UNITED STATES PATENT AND TRADEMARK OFFICE

APPLICATION NO.	FILING DATE	FIRST NAMED INVENTOR	ATTORNEY DOCKET NO.	CONFIRMATION NO.
10/614,532	07/07/2003	David H. McFadden	54330/322597	9062

Office Action Summary	Application No. 10/614,532	Applicant(s) MCFADDEN, DAVID H.	
	Examiner Sarah Suereth	Art Unit 3749

Segment of Fig. 8 of Smith
(the examiner has added lead arrow and text)

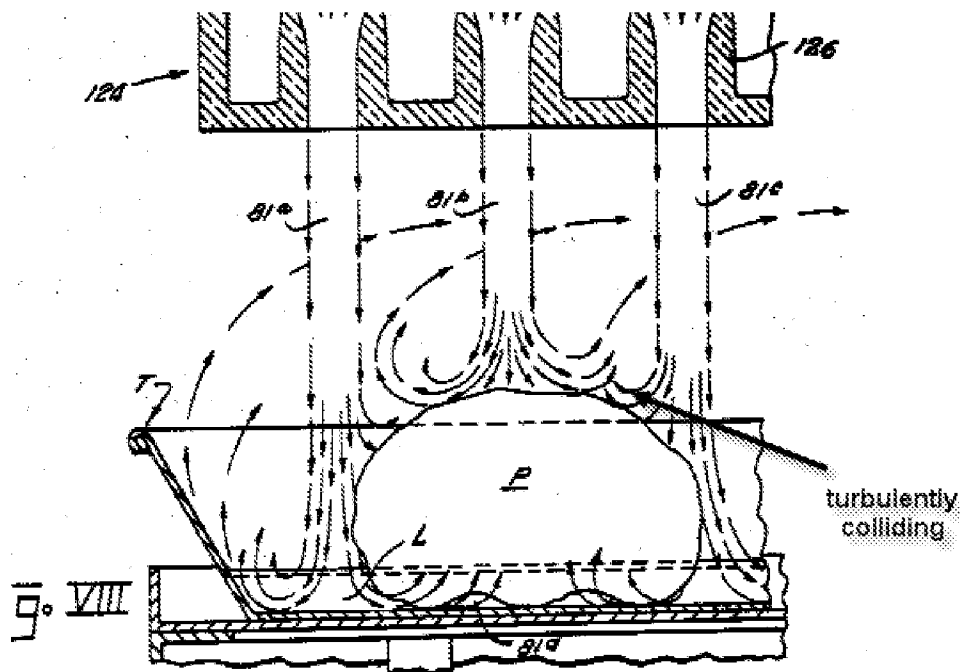
Regarding the limitation that the food is cooked by turbulently colliding gas flows, gas from the Smith openings is provided in the form of jets (81). As shown particular in Fig. 8, a first gas jet (81b) and a second gas jet (81c) are provided to strike a food product (P) and are considered to collide turbulently in close proximity to a surface of the food product to desirably enable "very rapid heat transfer and very rapid water vapor removal from the surface of the product" (see col. 10, lines 45-51). The following is a segment of Fig. 8 of Smith to further illustrate what the examiner considers to be "turbulently colliding" gas flows:

Further, the examiner notes that Smith expressly describes that jets (81), when striking a solid surface will be transformed, into a "turbulent mushroom shaped pressure area" (see col. 11, lines 6-11). While this discussion is in the context of the jets striking the bottom of the food product, the examiner considers that a person of ordinary skill in the art would recognize that the "turbulent mushroom shaped pressure area" would also result on the top of the food product (as shown for instance in Fig. 8 of Smith).
